RE: **Global Storage- Coors**
3421 Coors Blvd NW
Grading and Drainage Plan
Engineer's Stamp Date 6/26/18
Hydrology File: G11D071

RE: GLOBAL STORAGE – COORS
Conceptual Grading and Drainage Plan
Hydrology File: G11D071

Supplemental Grading & Drainage Information

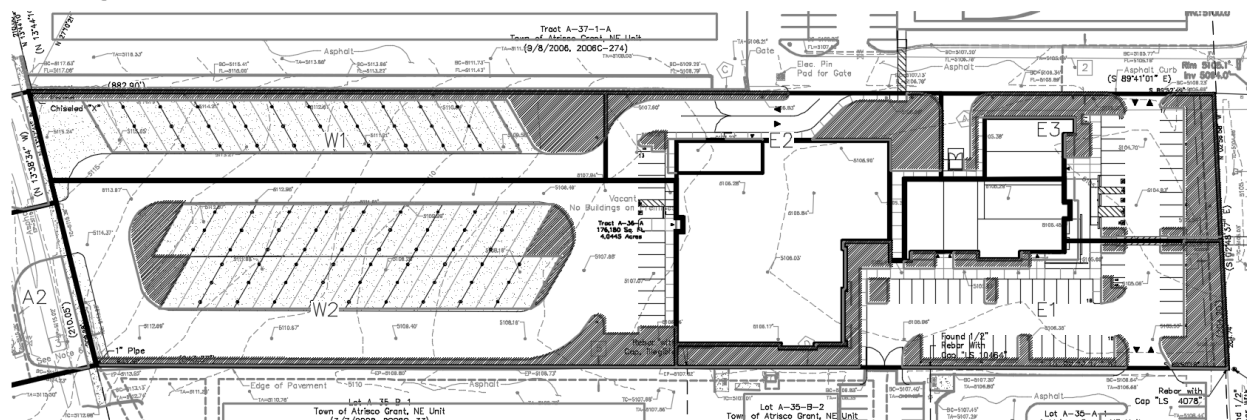
For first flush stormwater retention requirements: With regards to first flush requirements, the area of the overhead canopies will be considered impervious area. The image below shows the pervious areas hatched with the compacted base course as Land Treatment 'D' due to the cover.

Total pervious = 31,977 sf (18.2%).

Total impervious = 144,203 sf (81.8%).

CONCEPTUAL
GRADING &
DRAINAGE PLAN
1 OF 2

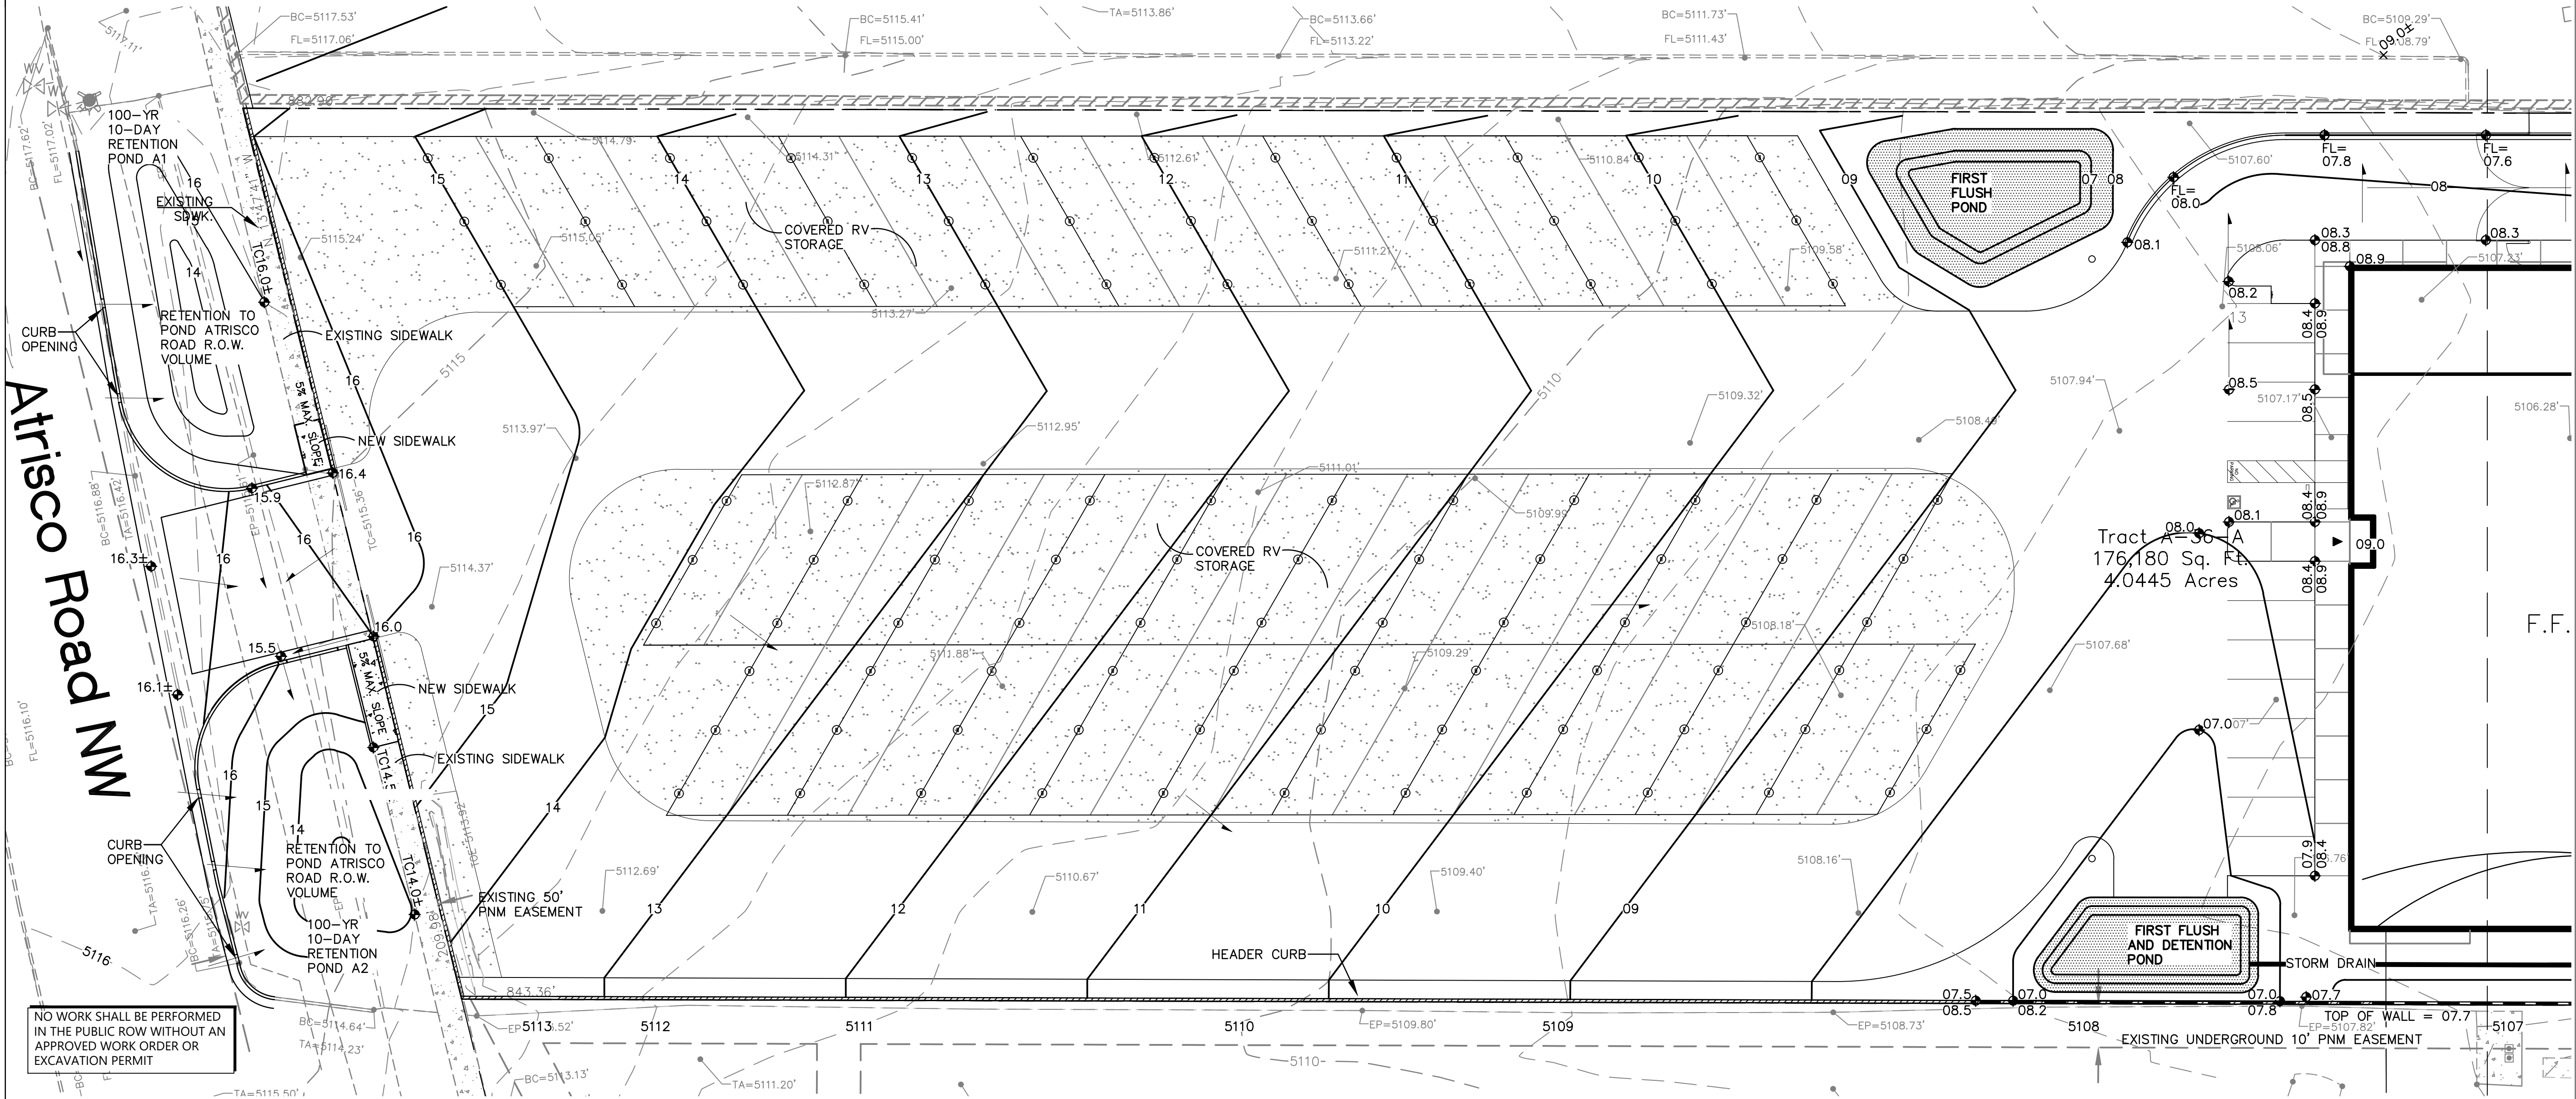
1. Remove all Conceptual markings.
2. There appear to be a few areas around the dumpster access where impervious areas are not being retained on-site. Please add detail to show how these areas are being captured. If unable to capture and retain on-site, quantify the first flush bypass volume and state on plans. Payment of fee in-lieu will then be required at building permit.

4. The retention areas along Atrisco will be sized to retain the 100-year 10-day volume (see SG&D Drainage Basin calculations for Basins A1 and A2). Per the note on sheet CG-101, *No work shall be performed in the public ROW without an approved work order or excavation permit."* Per the calculations, Basin A2 will generate 0.7 cfs. Approximately half of this basin will drain to Pond A2 via the 2' wide curb opening in the entrance drive. Per the weir calculation (see SG&D), a 2' wide curb opening would pass 2.36 cfs at 0.5' depth (top of waterblock) which supports the smaller waterblock.
5. Final first flush retention ponding will be provided as part of the construction document submittal for Building Permit. All first flush discharge from impervious areas will be routed to on-site first flush retention ponds. We understand that, in the event this

cannot be accomplished as part of the building permit design, the Owner will be required to submit the payment of fee in-lieu prior to building permit approval.
